**ADDENDUM NO.:** 02  
**PROJECT NAME:** CDOT Alleys (Various Locations) – Package 5  
**PROJECT NO.:** 22912 thru 22918  
**CONTRACT NO.:** C1626  
**DATE OF ISSUE:** June 26, 2025

### NOTICE OF CHANGES, MODIFICATIONS, OR CLARIFICATIONS TO CONTRACT DOCUMENTS

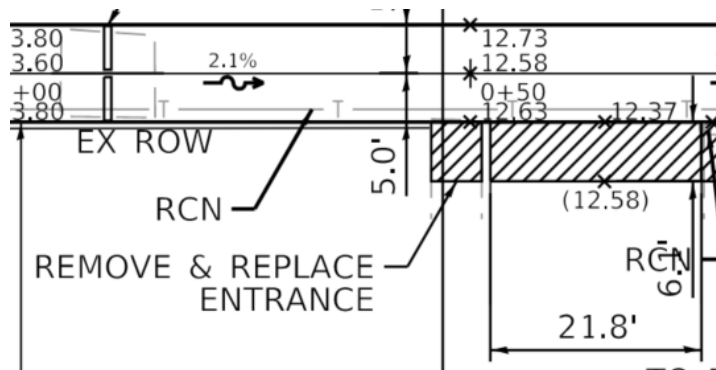
**Question:** Please provide cross sections or details for garage aprons and entrances.

**Response:** Details may be found in the respective drawings when applicable. Example below is from page 6 of 24 for project 22912.
